ZONING ADMINISTRATOR MEETING AGENDA

2. SC23-0015 – Yun Li – 628 Cuesta Drive

Design Review for the modifications to an approved residential addition (SC21-0046) from a two-story house with 2,065 square feet at the first story and 1,120 square feet at the second story to a two-story house with 2,257 square feet at the first story and 1,077 square feet at the second story. This project is categorically exempt from environmental review under 15301 of the California Environmental Quality Act (CEQA). *Project Planner: Liu*

FROM: Jia Liu, Associate Planner

**EXISTING /
 PROPOSED
 SITE PLAN**

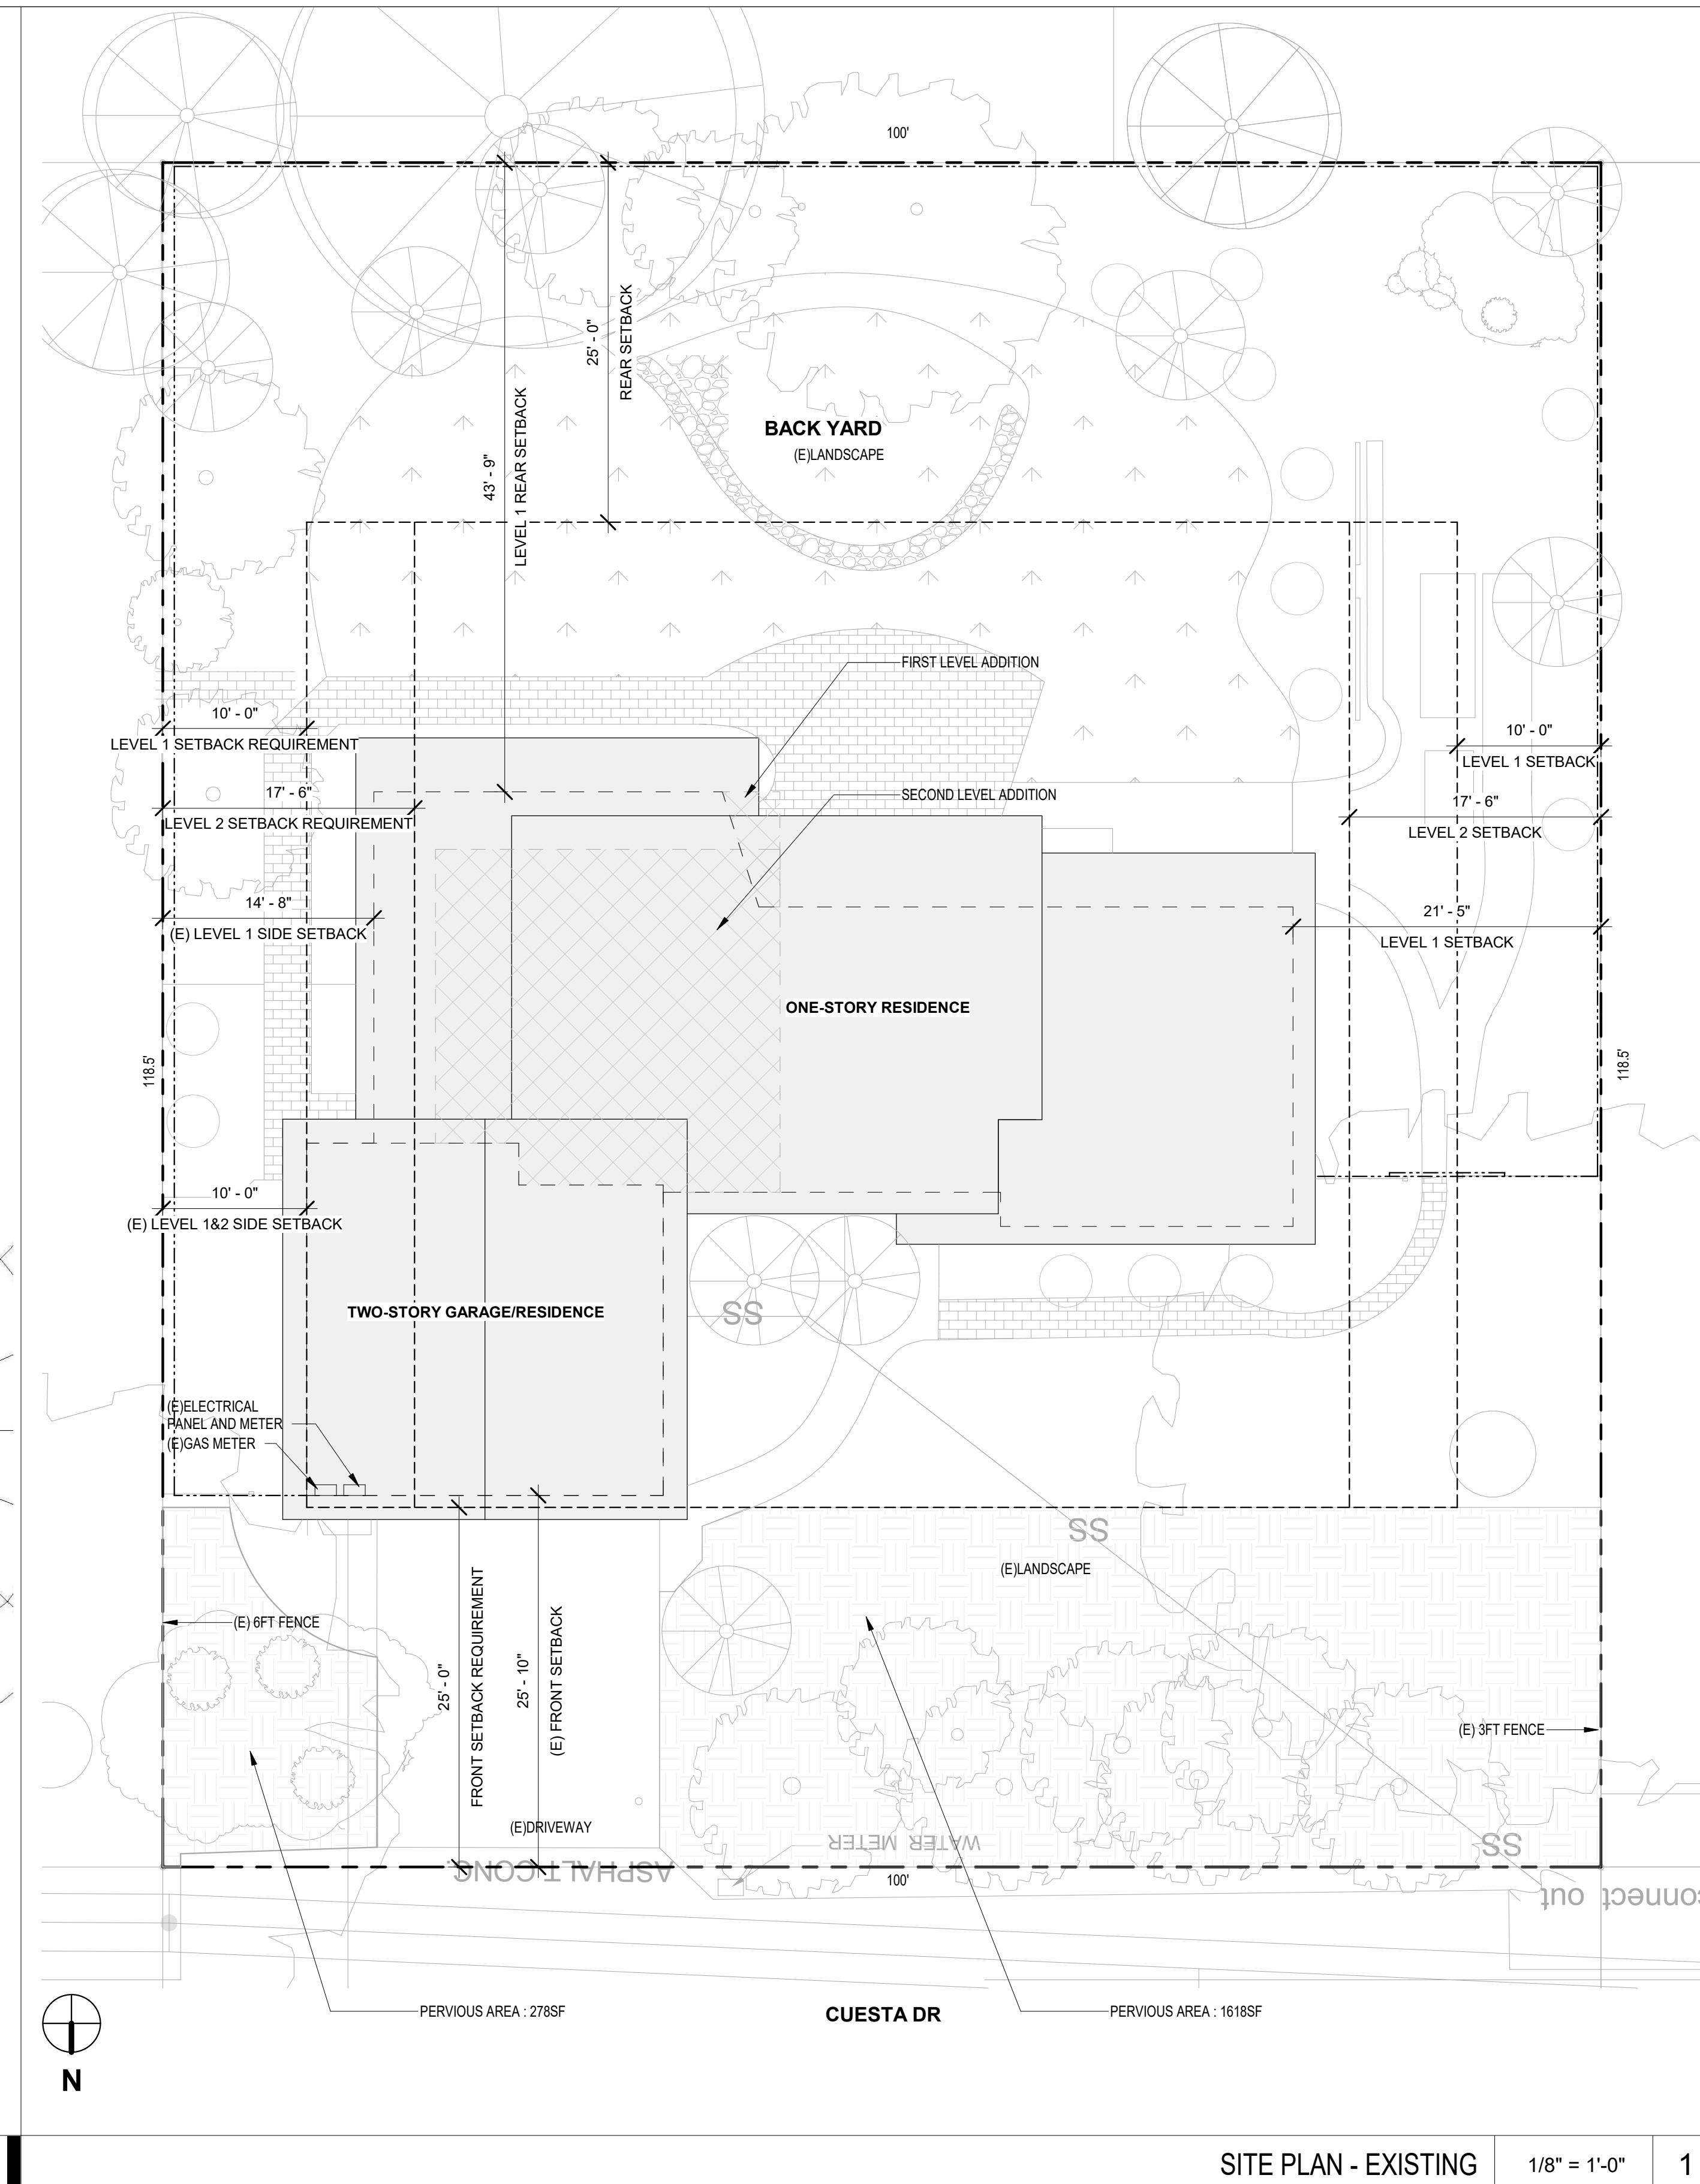
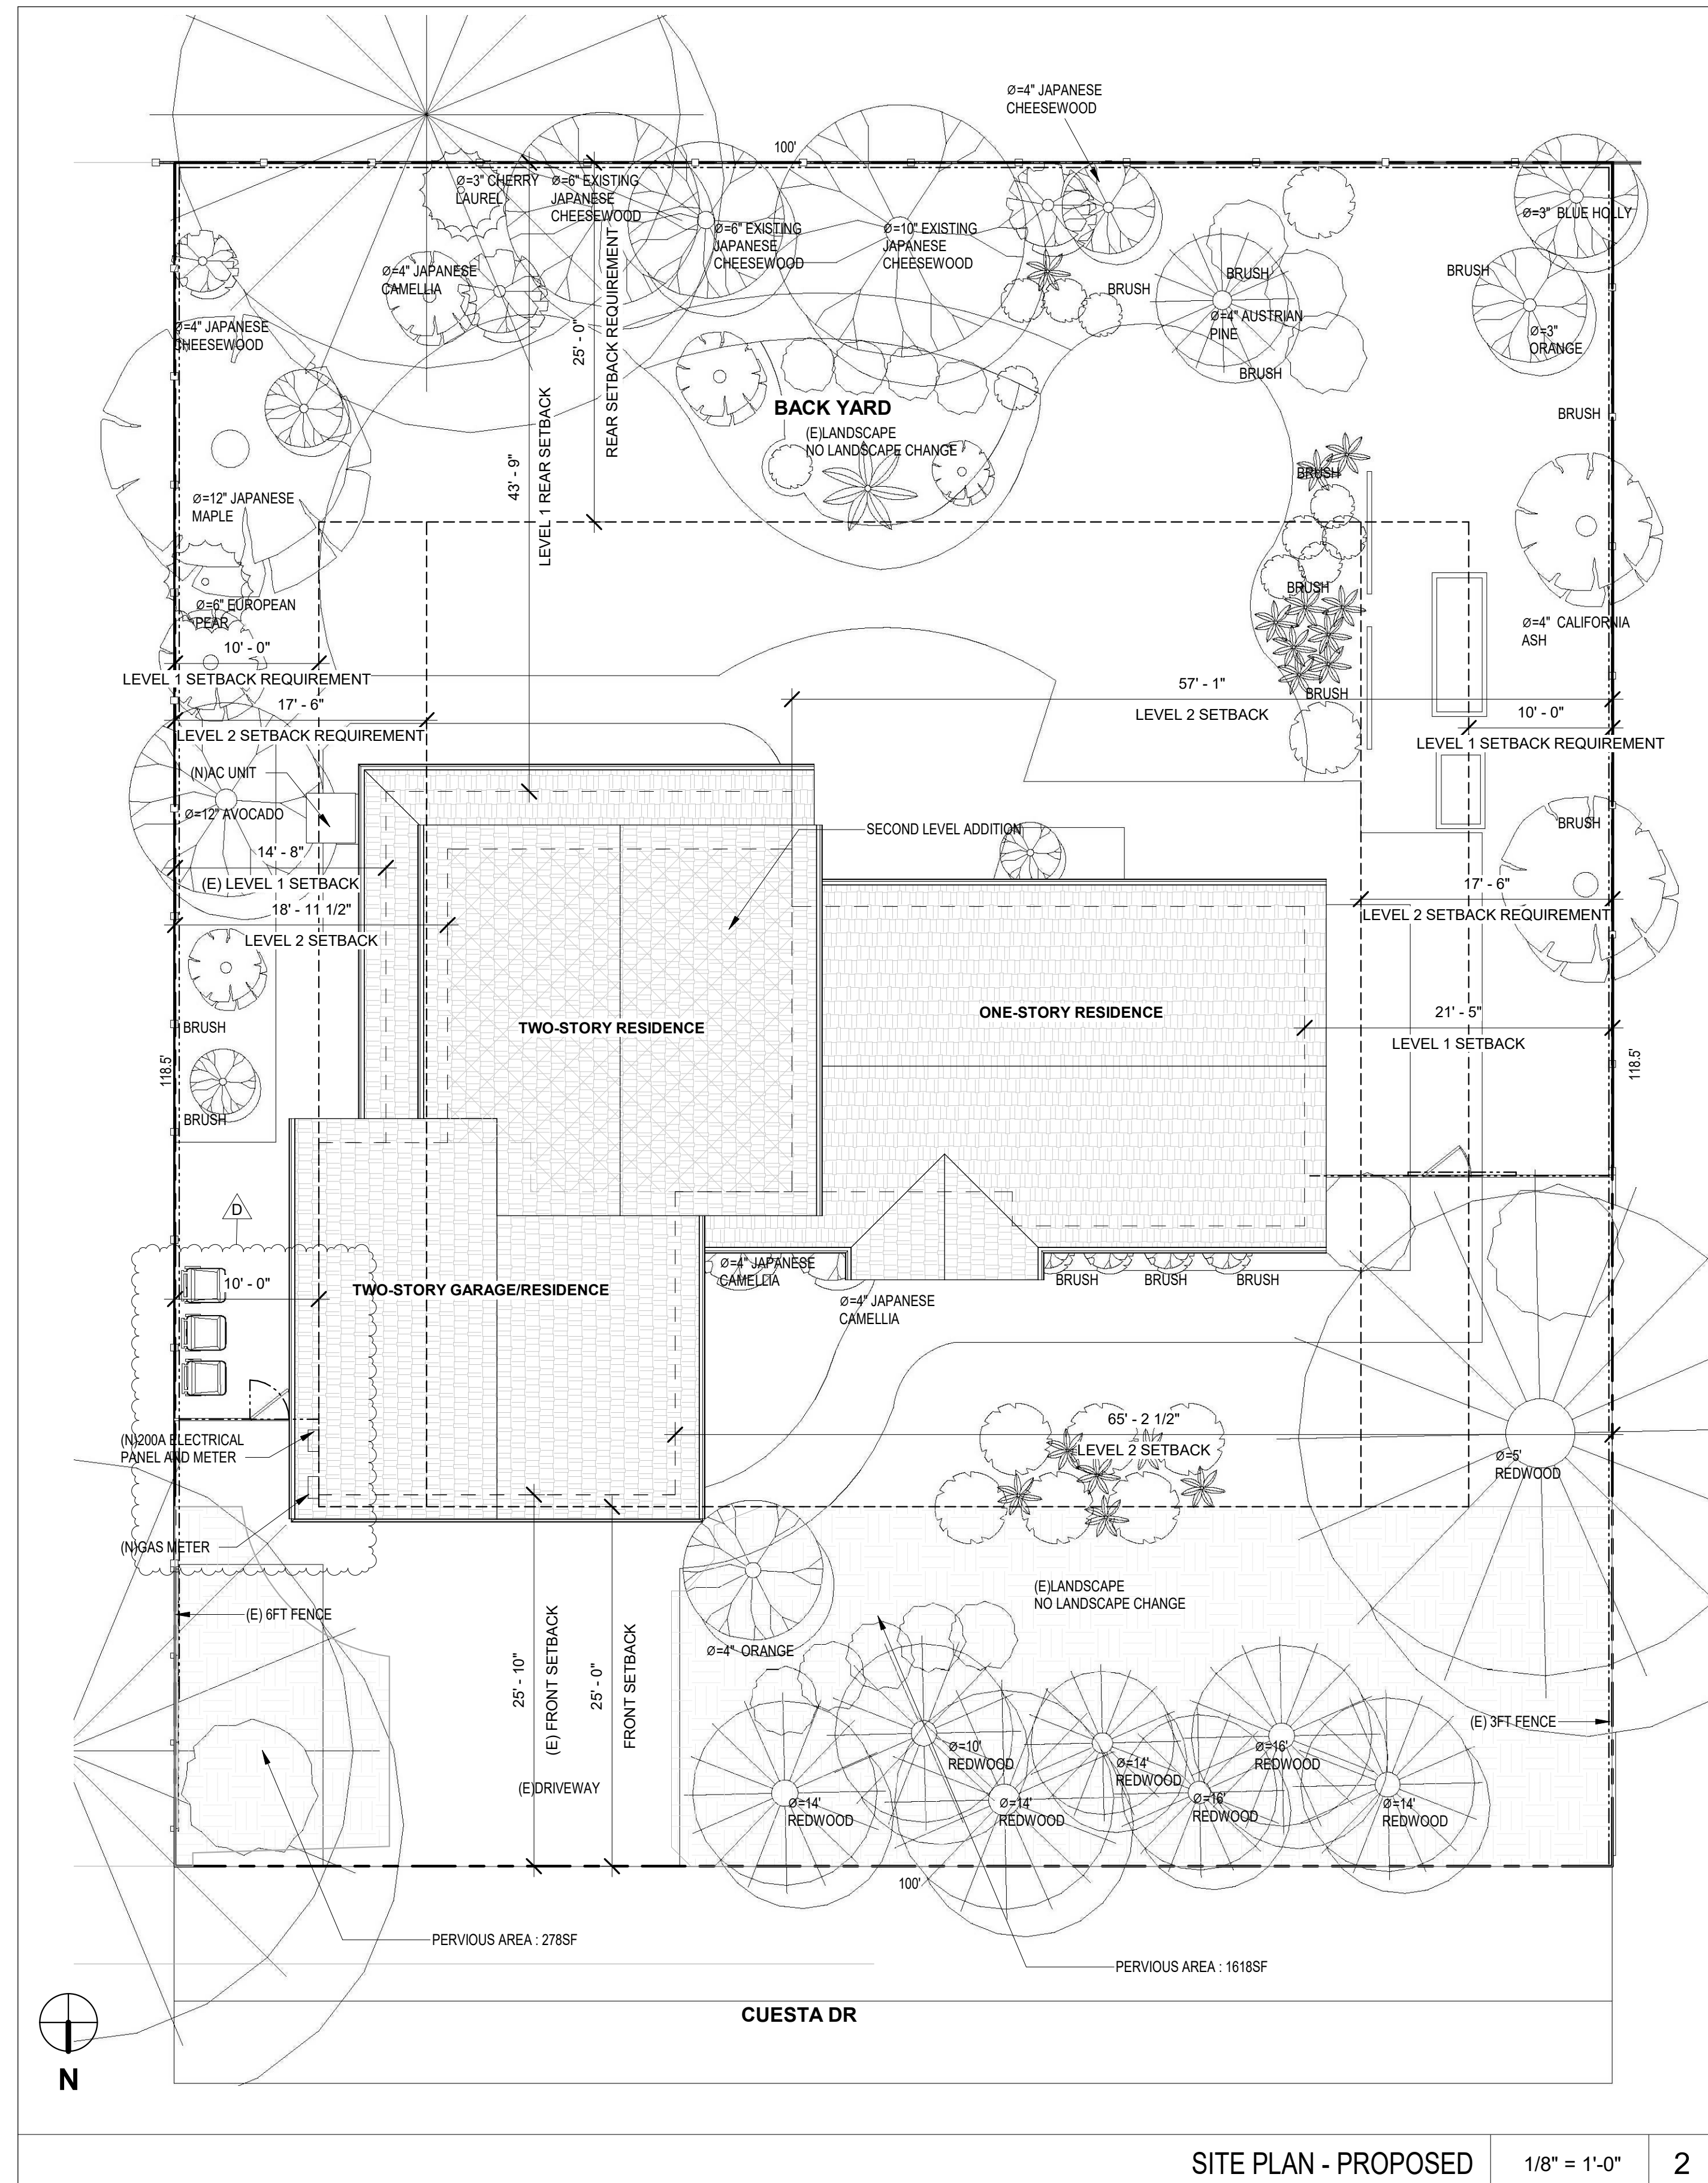
Update the construction drawing on Sheet A-1, the “Proposed Lot Coverage” shall be revised from 2,066 square feet to 2,113 square feet to include the proposed porch.

EXISTING ELEVATION- NORTH 1/4" = 1'-0" 2

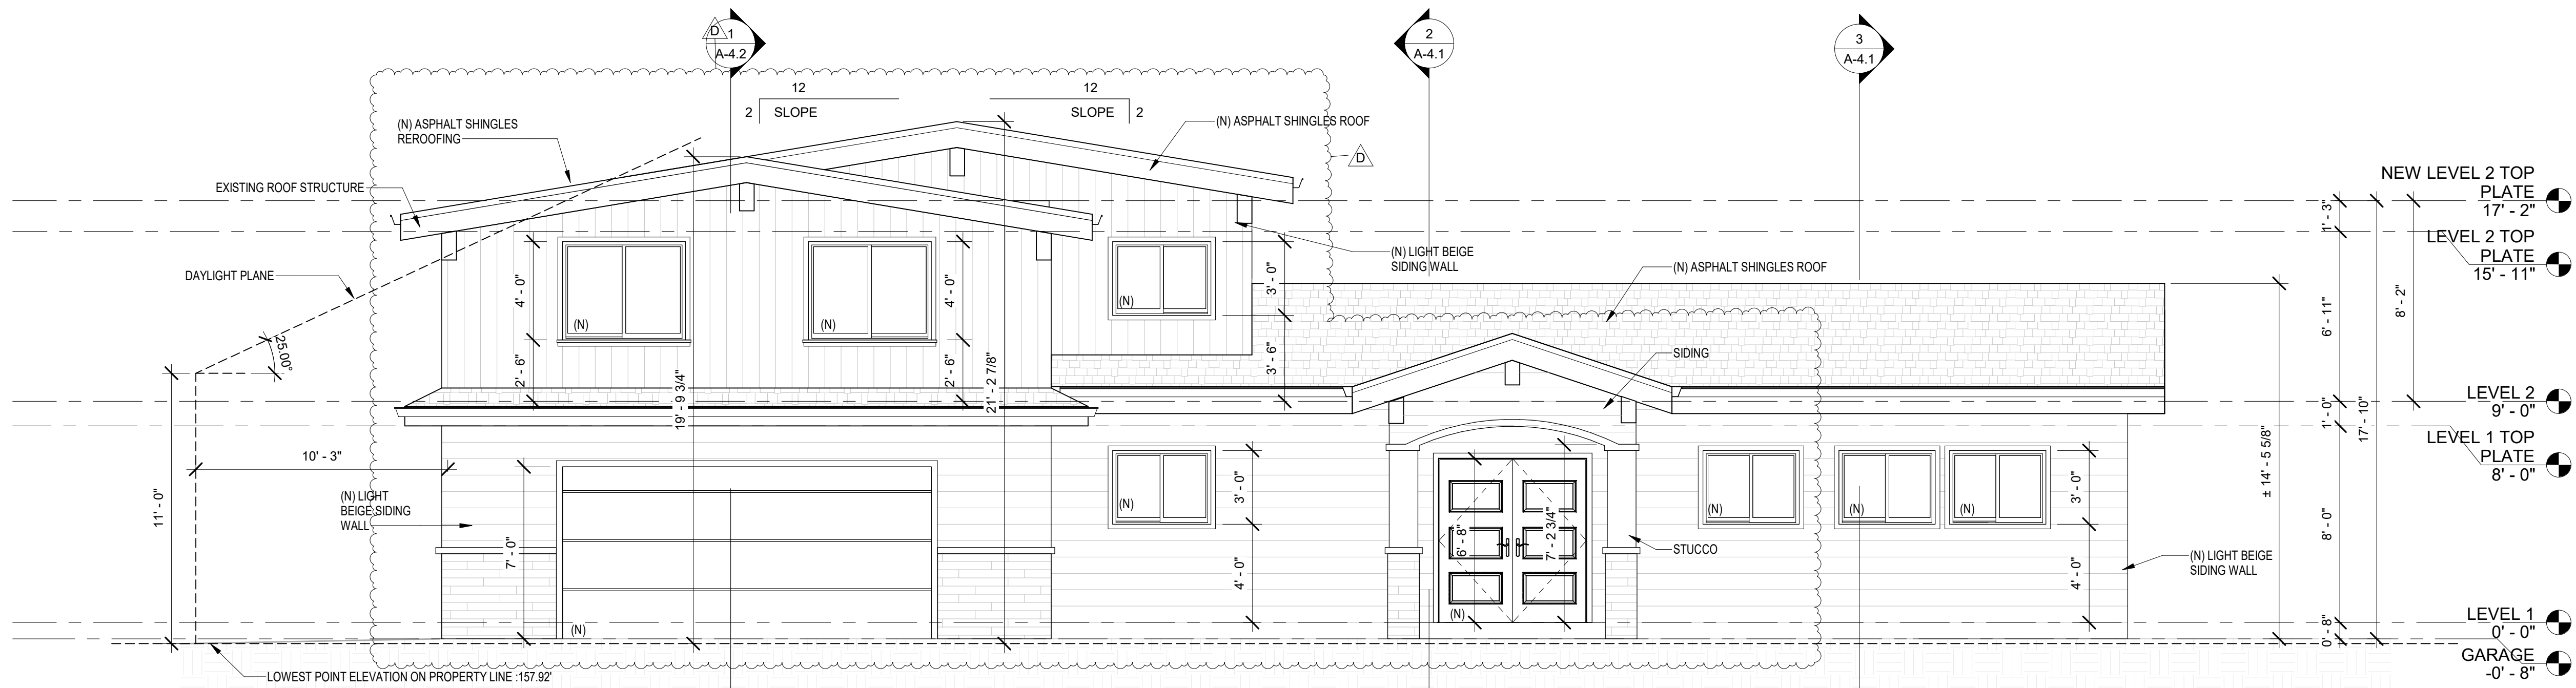
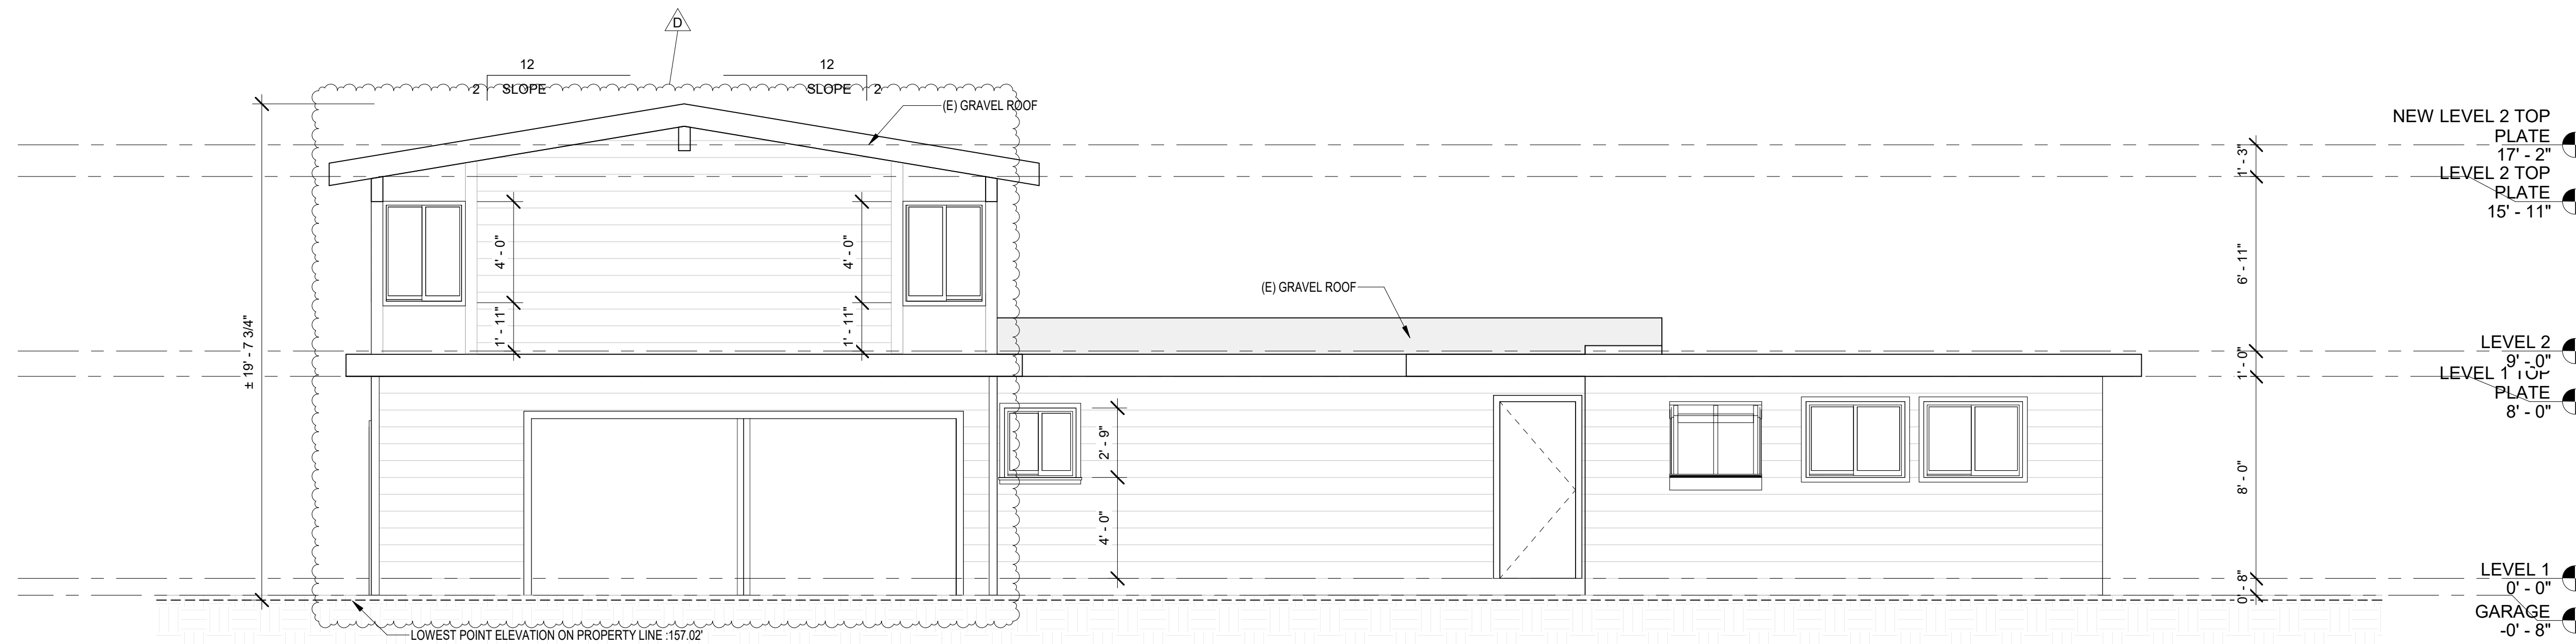
- There are discrepancies between the depicted existing elevations and the actual building elevations. Applicant shall revise the existing elevation plans to reflect the actual conditions;

1. The applicant communicated with the adjacent neighbors and provided a support letter and email responses from the adjacent neighbors to document the agreement of the current design.
2. The existing front elevation was updated to reflect the real conditions.
3. The materials board on Sheet A-6 was updated with more details.
4. Following the Section 5.4 of the Residential Design Guidelines, the applicant made the following modifications to mitigate the bulk and massing:
 - Added architectural elements including a porch to the existing entrance and roof projections between the first story and existing second story;
 - Applied distinct exterior materials including horizontal siding at the first floor with stone veneer wainscoting at the garage and vertical siding at the second floor; and
 - Centered the garage door and made the existing garage and second-story element symmetric.
